MATANUSKA-SUSITNA BOROUGH

ABBREVIATED PLAT AGENDA
ASSEMBLY CHAMBERS
350 EAST DAHLIA AVENUE, PALMER

STAFF REVIEW AND RECOMMENDATIONS
PUBLIC HEARING
APRIL 9, 2025

ABBREVIATED PLAT: BUTTE VIEW
LEGAL DESCRIPTION: SEC 26, T17N, R02E S.M., AK
PETITIONERS: ROSS JOHANSSON
SURVEYOR/ENGINEER: HANSON LAND SOLUTIONS
ACRES: 2.77 +/- PARCELS: 2
REVIEWED BY: CHRIS CURLIN CASE #: 2025-035

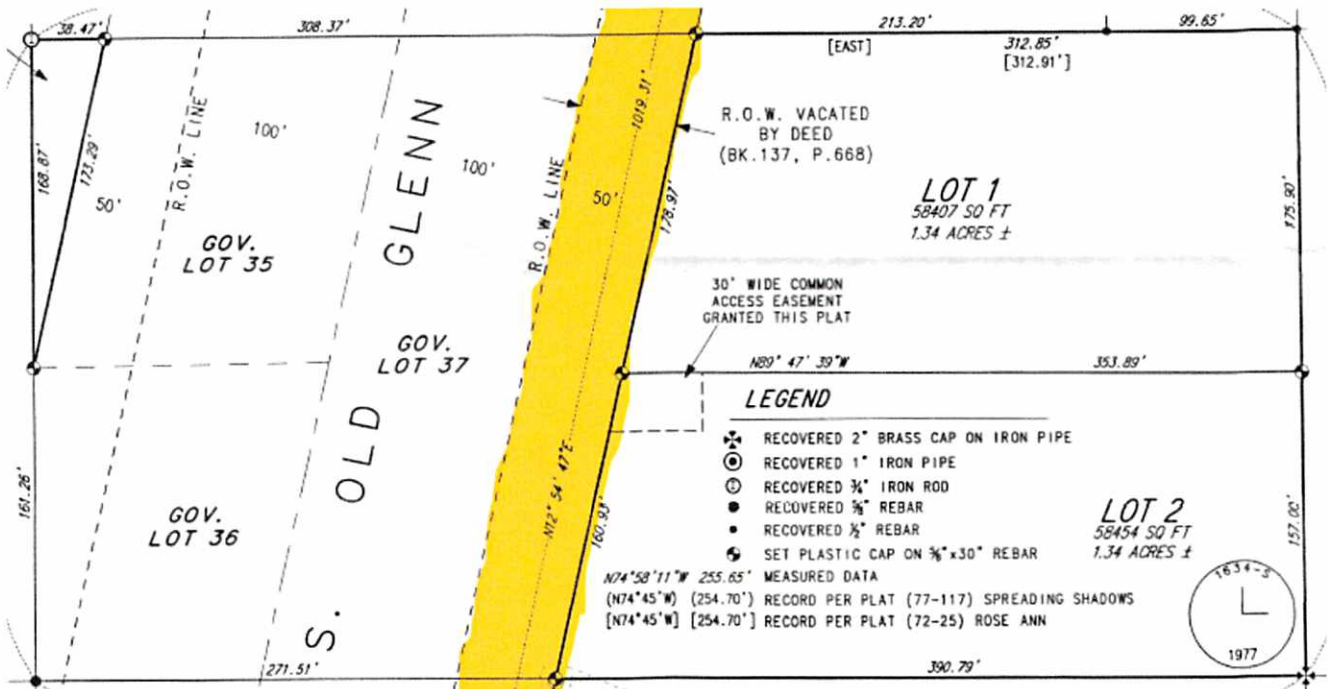
o Check underlying ownership of previously vacated Old Glenn Highway right of way in BK.137, P.668. Before DOT&PF can issue an access permit, DOT&PF expects to see codified agreement across fee interest under previously vacated right of way interest per deed BK.137, P.668 and as highlighted in the below diagram.

DOT&PF cannot permit legal access unless an access right through the right of way is shown.

Staff notes this is COA # 5.

5. Provide platting staff with a codified agreement across fee interest under previously vacated right of way interest per deed BK.137, P.668.
6. Add a plat note regarding the restricted use of the utility lot, including not allowing an individual septic system to be installed.

EXHIBIT C-1

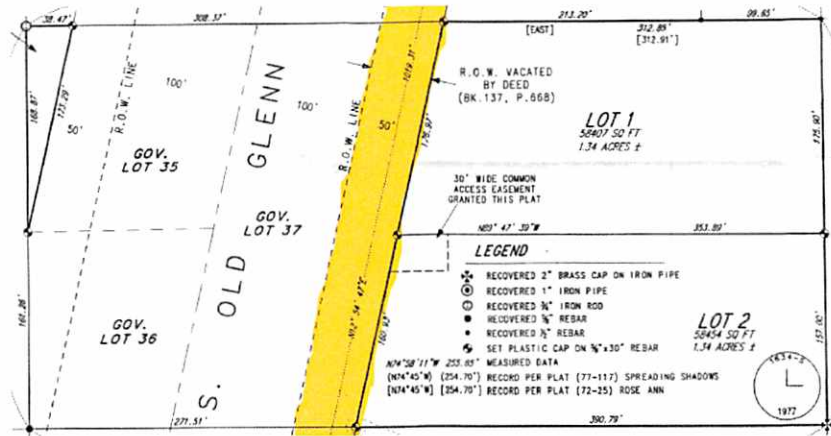
- Check underlying ownership of previously vacated Old Glenn Highway right of way in BK.137, P.668.

- Before DOT&PF can issue an access permit, DOT&PF expects to see codified agreement across fee interest under previously vacated right of way interest per deed BK.137, P.668 and as highlighted in the below diagram.

- DOT&PF cannot permit legal access unless an access right through the right of way is shown.
